**FORD:**

2015-2016 Transit

**TSB 16-0081 (Continued)**

Figure 2 - Article 16-0081

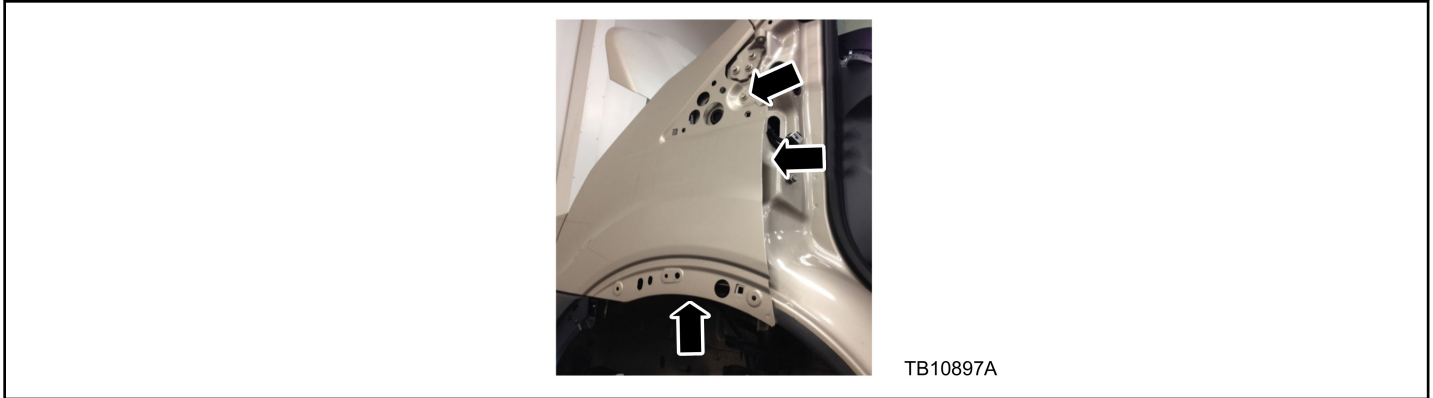
3. Remove the fender splash shield. Refer to WSM Section 501-02.
4. Remove the lower fender bolt, inner fender to body side bolt and fender to body side bolt. (Figure 2)

5. Remove and discard the door hinges from the A-pillar and the door.
6. Repair any metal damage to the fender and door as required.
7. Paint the new door hinges. Paint the door and fender as required.
8. Attach the new hinges to the A-pillar.
  - a. Tighten the hinge to A-pillar bolts. Torque to 35 Nm (26 lb-ft).
  - b. Tighten the hinge alignment pin nut. Torque to 10.5 Nm (93 lb-in).
9. Install the lower fender bolt, inner fender to body side bolt and fender to body side bolt. (Figure 2)
  - a. Tighten the fender bolts. Torque to 9 Nm (80 lb-in).
10. Install the door. Refer to WSM, Section 501-03.
  - a. Tighten the hinge to door bolts. Torque to 62 Nm (46 lb-ft)
11. Replace the front door check arm. Refer to WSM Section 501-03.
12. Adjust the front door alignment. Refer to WSM Section 501-03.
13. Install the fender splash shield.
